Reference: Planning Application Number WSCC/007/24 – Installation of Integrated Constructed Wetlands (ICW) and associated infrastructure at land adjacent to Staplefield Wastewater Treatment Works (WTW)

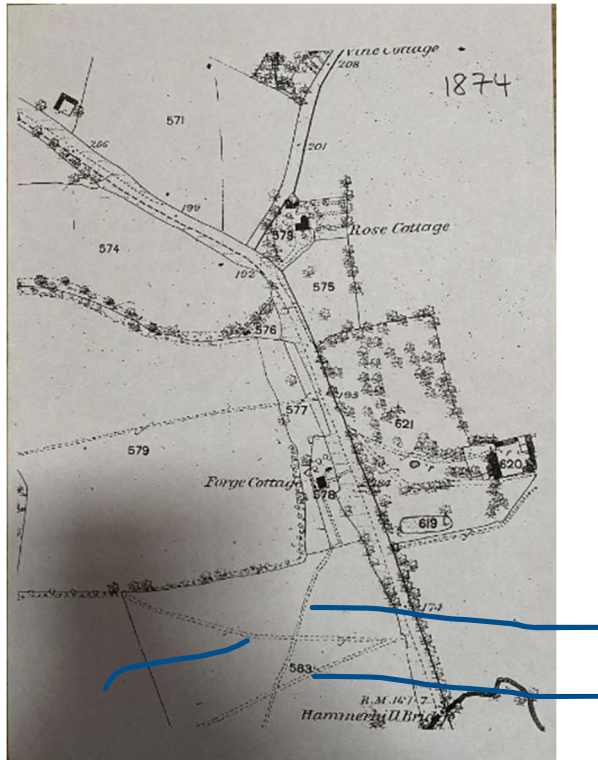
- Impact on a Grade II listed building. Chiffley Grange is grade listed II property and our curtilage is 175 metres to the north boundary of the application. It is believed the listing has not been taken into consideration appropriately.
- There was an ancient property in the field above the application called **Forge Cottage**, which is missing from the *Historic Environment Desk Based Assessment* reports. It is shown on the historic maps of 1874 & 1894 and is also shown on the Tithe map of about 1836. In addition, this property has a well (marked **W** below) which still appears to be active. In section 4.4.5 on page 20 of 51 of the same pdf it is

- There is another brick-built World War II Pillbox that is missing off the *Historic Environment Desk Based Assessment RevE Part 1.pdf*. It is circled below in blue and is in the north hedge row, likely to jut into the field of the application – see the blue circle in the photo below for its position. This needs to be addressed.
Note: It is **not** the pill box in Photo B.8

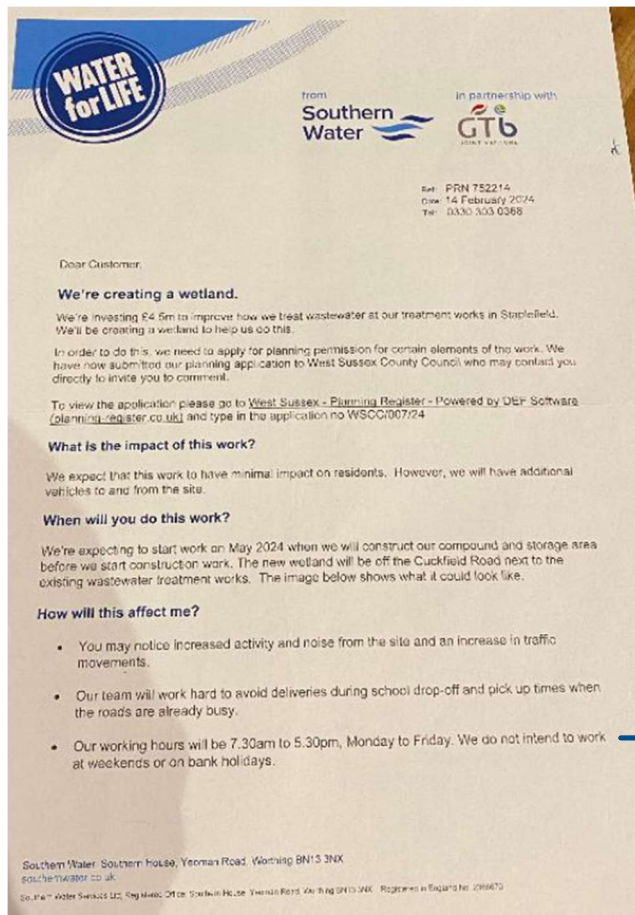
- This new industrial site is proposed for a 5 and half day week construction operation but the Southern Water letter to Staplefield residents date 14th February, says working hours of Monday to Friday 7:30am to 5:30pm. This is unacceptable for residents, with construction at 50 hours a week. There should be no work on a Saturday as the letter (pinpointed in blue) mentions below. There is a statutory right to enjoyment of one's own homes and gardens.
